2 Table 33–11—PSE output PI electrical requirements for all PD classes, unless otherwise specified

10 **33.2.7.5 Output current in POWER_UP mode**

21 **Change the text of 33.2.7.5 as follows:**

Figure 33-13 – $I_{nrush-2P}$ and I_{nrush} current and timing limits, per pairset in POWER_UP

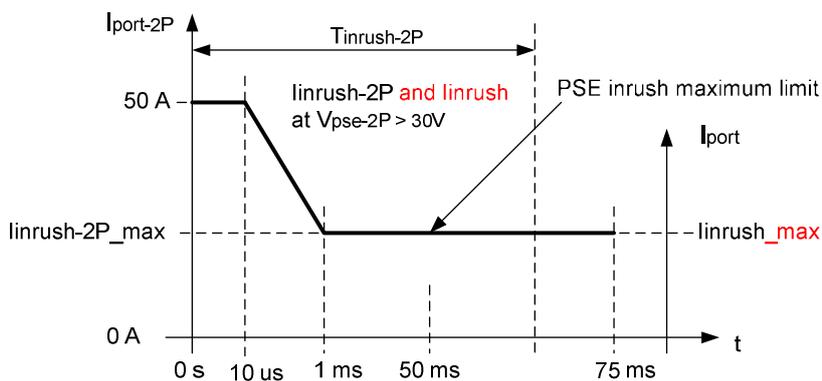
37 **Replace Figure 33-13 with the following:**

41 The PSE inrush maximum limit, $I_{PSEIT-2P}$, is defined by the following segments:

$$I_{PSEIT-2P}(t) = \left. \begin{array}{ll} 50.0 & \text{for } 0 < t < 10.0 \times 10^{-6} \\ \text{TBD=function of} & \text{for } 10.0 \times 10^{-6} \leq t < 0.001 \\ \text{(t, Iinrush-2P_max)} & \\ \text{Iinrush-2P_max} & 0.001 \leq t < 0.075 \end{array} \right\} \text{A} \quad (33-5)$$

$$I_{PSEIT-2P}(t) = \left. \begin{array}{ll} 50 & \text{for } 0 < t < 10 \times 10^{-6} \\ y1 + \frac{(50 - y1) \times (0.001 - t)}{99 \times 10^{-5}} & \text{for } 10 \times 10^{-6} < t < 0.001 \\ y1 & \text{for } 0.001 < t < 0.075 \end{array} \right\} \quad (33-5)$$

47
 48 The variable y1 is the maximum value of Iinrush-2P or Iinrush provide in Table 33-11.
